SUBJECT: Savannah River Site's Responses to the Regulatory Comments on the Effectiveness Monitoring Report (EMR) for the C-Area Groundwater (CAGW) Operable Unit Removal Action (U) July 2020 through June 2021 (SRNS-RP-2021-04758, Revision 0, September 2021) SEMS Number: 82

SRS Responses to EPA comments on the Effectiveness Monitoring Report (EMR) for the C-Area Groundwater (CAGW) Operable Unit Removal Action (U) July 2020 through June 2021 (SRNS-RP-2021-04758, Revision 0, September 2021) SEMS Number: 82

SRS Responses to EPA Comments on the Effectiveness Monitoring Report (EMR) For The C-Area Groundwater Operable Unit Removal Action (U) July 2020 Through June 2021 Sems Number: 82, SRNS-RP-2021-04758, Revision 0, September 2021, Savannah River Site, South Carolina

Figure 2. CRW026C (co)metabolic enzyme microbial counts.

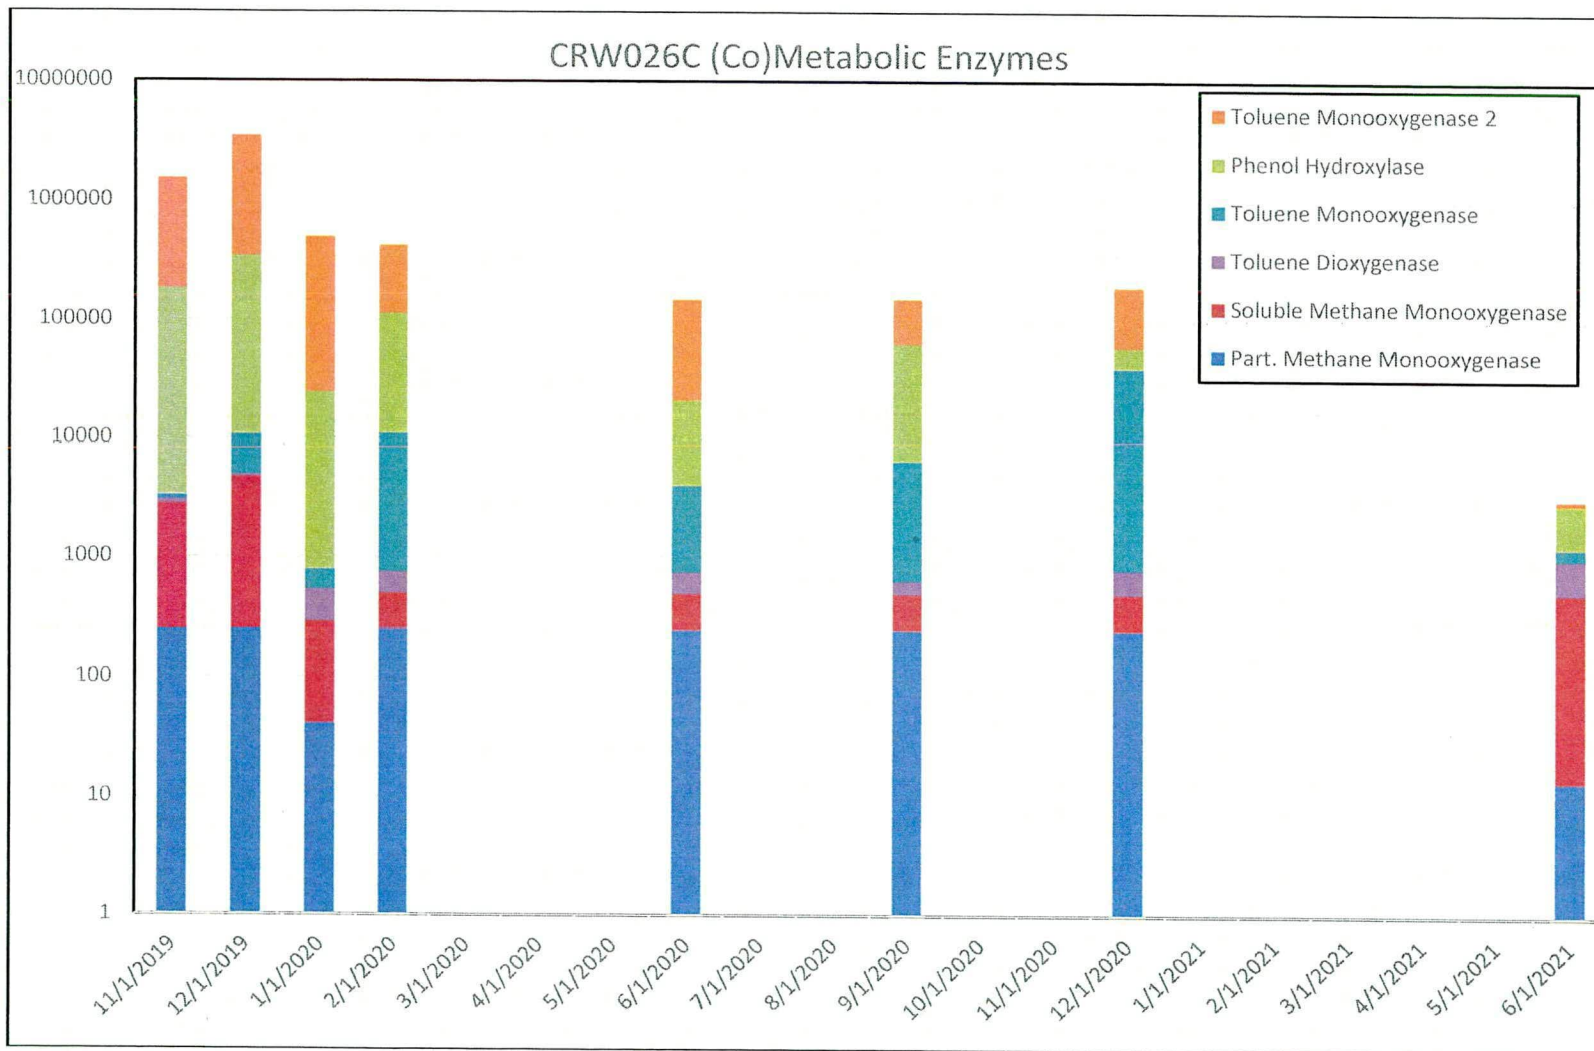
2. It is unclear whether petroleum fuel contaminants (e.g., toluene) are present in groundwater that would impact the biodegradation of chlorinated volatile organic compounds (cVOCs). For example, the footnote in Section 4.3.2 (CAGW OU Groundwater Sampling and Analyses), Page 9 of 94, states that “Only well CRW022D samples are analyzed for TPH [total petroleum hydrocarbon] diesel range organics, as it monitors a remediated diesel storage tank site.” Additionally, the text in Section 4.4.1.9 (BioTrap QuantArray-Chlor® Microbial Data), Page 18 of 94, states aerobic (co)metabolic microbial activity is indicated by detectable levels of toluene monooxygenase and toluene monooxygenase 2 on the BioTraps at nearly all monitoring wells. As such, it is unclear whether the detectable levels of toluene monooxygenase and toluene monooxygenase 2 on the BioTraps indicates the presence of toluene in groundwater. *Please revise the EMR to discuss the presence of petroleum fuel contaminants in groundwater and how this condition impacts biodegradation of cVOCs in groundwater.*
